re: **Geotechnical Review – Grading and Landscaping Plans**
Proposed Residential Development
475 Terry Fox Drive – Ottawa, Ontario

file: PG7418-MEMO.02

Figure 1 – Recommended Lightweight Fill Location Plan

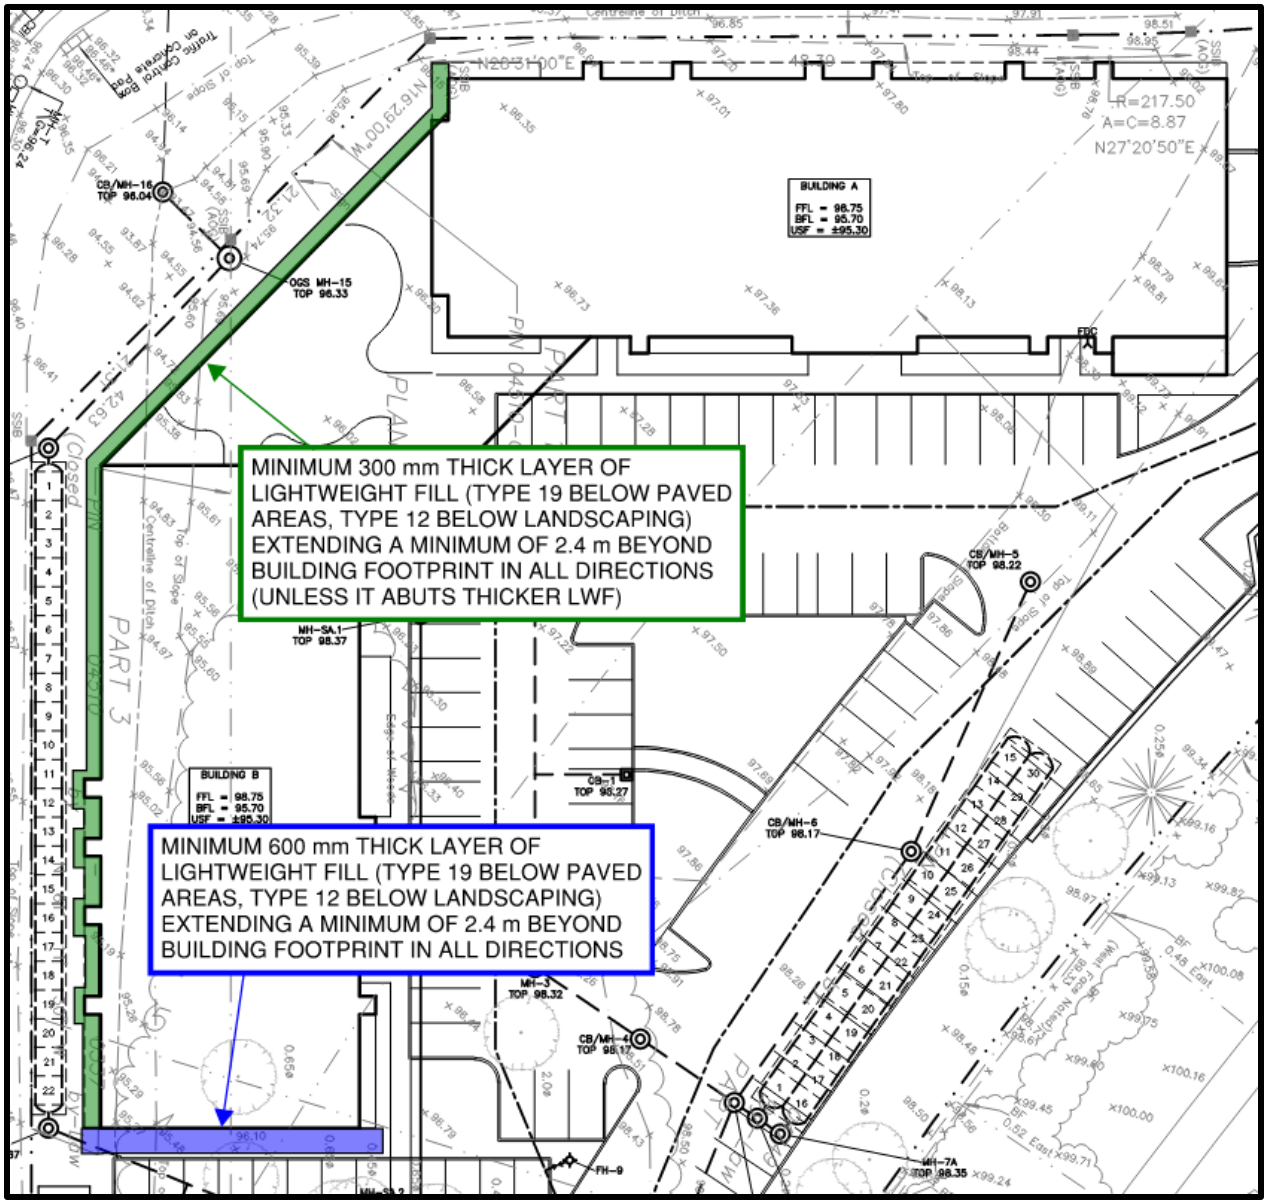
However, some grade raise exceedances were identified in areas surrounding the proposed Building A and Building B. For these areas, lightweight fill is recommended to be placed per the locations identified in Figure 1 below to accommodate the grade raise restriction exceedances and mitigate long-term settlements.

Provided the proposed grading is accommodated using lightweight fill as described in this memorandum, the proposed grading for the proposed development is considered acceptable from a geotechnical perspective.

Lightweight fill (LWF) should consist of EPS (expanded polystyrene) Type 19 and Type 12 geofoam blocks throughout hardscaped (paved or other areas with concrete surface features) and landscaped areas, respectively. The LWF is recommended to be placed a minimum of 500 mm above any perimeter drainage sleeves/pipes provided to the main building structures foundation and the associated open-graded stone layers. The lightweight fill should be placed upon a flat soil surface. Therefore, the soil should be compacted to be relatively smooth and flat prior to installation. Consideration may be given to placing a thin layer of sand or stone dust to attain a relatively smooth/flat surface for placement.

The entire lightweight fill layer footprint is recommended to be covered with a layer of polyethylene (taped at seams) extending between the building footprint and outer edge of the layer and extending below its surface by a minimum of 100 mm at all edges of the lightweight fill layer.

If the lightweight fill will be located in an area of landscaping, a minimum 600 mm of soil cover is recommended to be provided to the lightweight fill layer to promote grass and associated vegetation to establish overtop the lightweight fill.
